SERVICE BULLETIN

APRIL 12TH, 2007

GAME NAME: CYCRAFT (INITIAL D3, CLUB KART)

SUBJECT: **JUMPER SETTING** FOR 2 OF SERVO CONTROL BD, MITSUBISHI

VIEW OF SERVO CONTROL BD

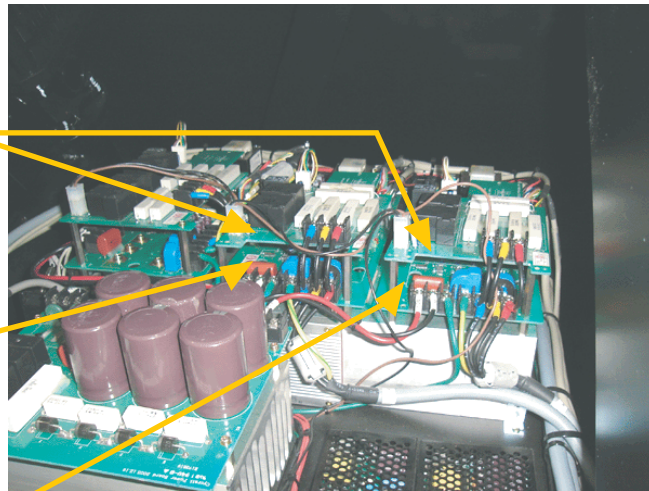
THERE IS JUMPER (2 PINS) ON 2 OF SERVO CONTROL BD, MITSUBISHI WHICH CONTROL THE **LEFT** AND **RIGHT** OF ACTUATOR MOTORS.

PLEASE MAKE SURE THAT 2 BOARDS HAVE DIFFERENT JUMPER AS BELOW.

LEFT NO JUMPER...

RIGHT NEED JUMPER!

TOP VIEW OF "SERVO CONTROL BD, MITSUBISHI"

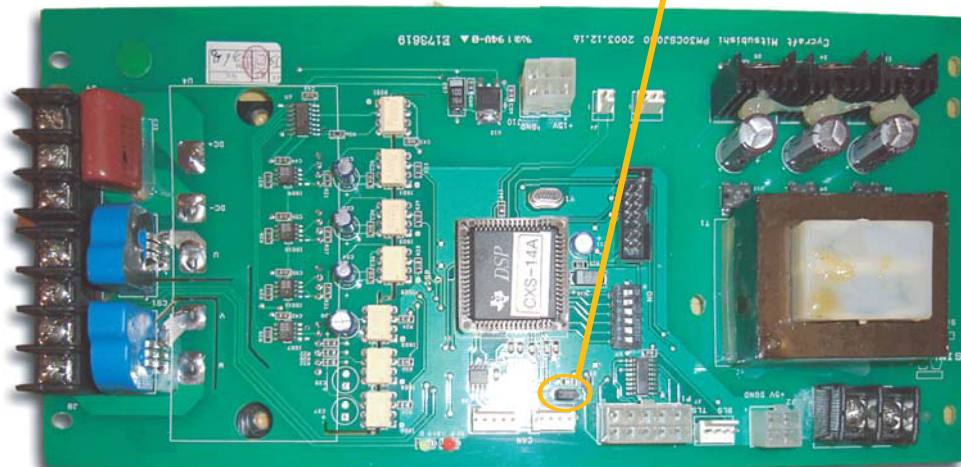
JUMPER (2 PINS)
